Comment Letter 11

January 10, 2014

Re: Comments on Draft EIR for proposed McKinley Village (P08-086)

### 28th Street

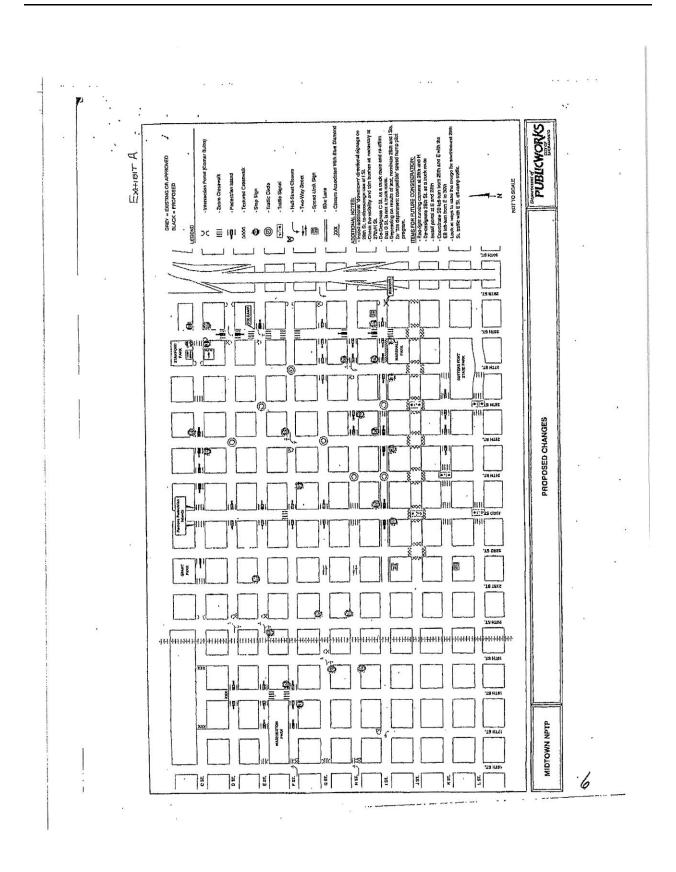
- 28th/C: Add an intersection portal at the southwest corner (southbound on 28th Street) to discourage eastbound C Street trucks from turning south on to 28<sup>th</sup>. Also add signage at 28<sup>th</sup>/C to encourage eastbound C Street and southbound 28<sup>th</sup> Street truck traffic to use 29<sup>th</sup> Street.
- 28th/D: Add pedestrian islands on 28th Street and high-visibility crosswalk on D Street (west side of 28<sup>th</sup>
- 28<sup>th</sup>).

28<sup>th</sup>/E: Reconstruct curb ramps at northeast corner (to discourage trucks from cutting corner).
